DAVIS-BESSE NUCLEAR POWER STATION, UNIT NO. 1

AMENDMENT TO FACILITY OPERATING LICENSE

Amendment No. 153  
License No. NPF-3

ATTACHMENT TO LICENSE AMENDMENT NO. 153

3/4.7.1.1 SAFETY VALVES (Continued)

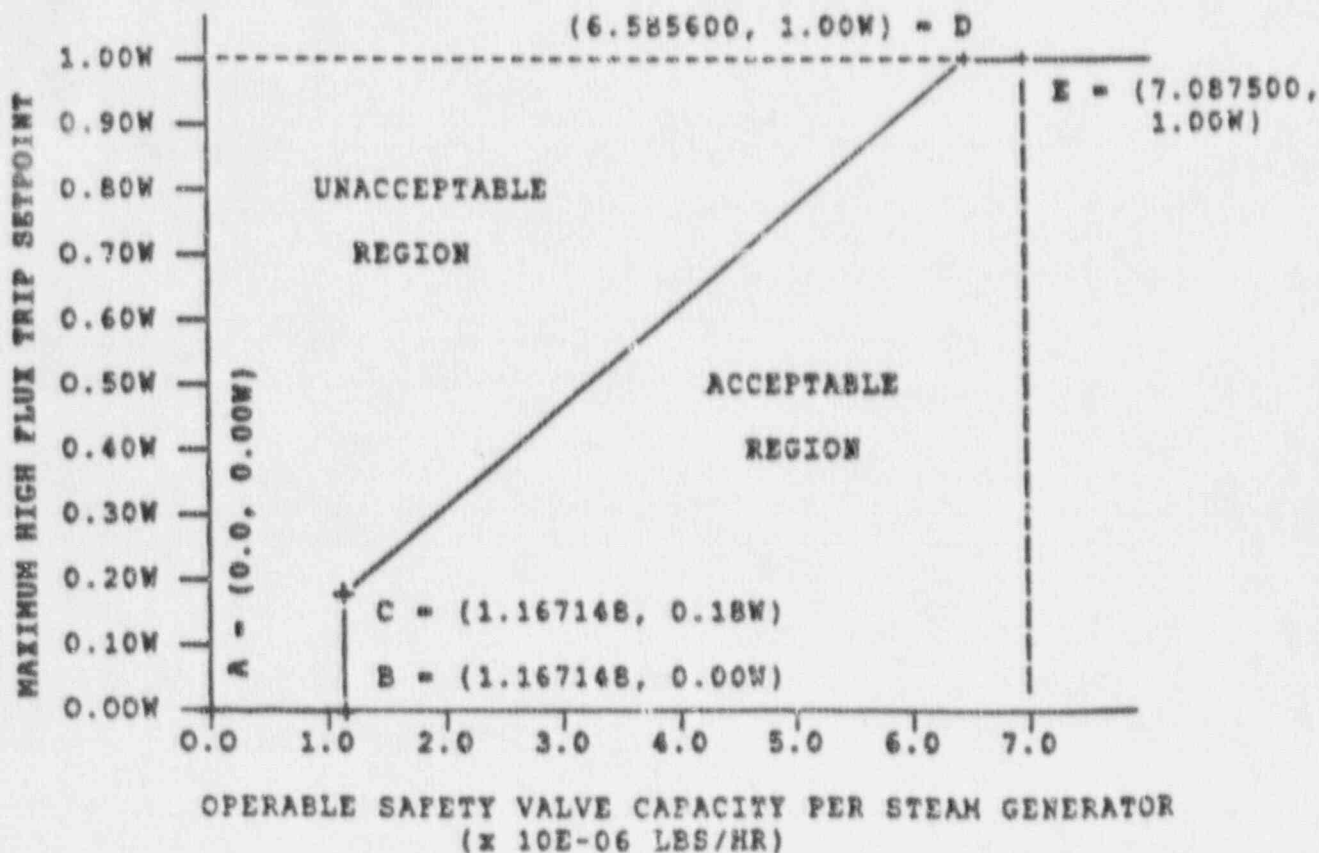
STARTUP and/or POWER OPERATION is allowable with safety valves inoperable within the limitations of the ACTION requirements on the basis of the reduction in secondary system steam flow and THERMAL POWER required by the reduced reactor trip settings of the High Flux channels. The reactor trip setpoint reductions are derived on the following bases:

$$SP = \frac{Y}{Z} \times W$$

- SP = Reduced High Flux Trip Setpoint (Not to exceed W)
- W = High Flux Trip Setpoint for four pump operation as specified in Table 2.2-1
- Y = Total OPERABLE relieving capacity per steam generator based on a summation of individual safety valve relief capacities per steam generator in lbs/hr
- Z = Required relieving capacity per steam generator of 6,585,600 lbs/hr

This equation is graphically represented below. Operation is restricted to the area below and to the right of line A.
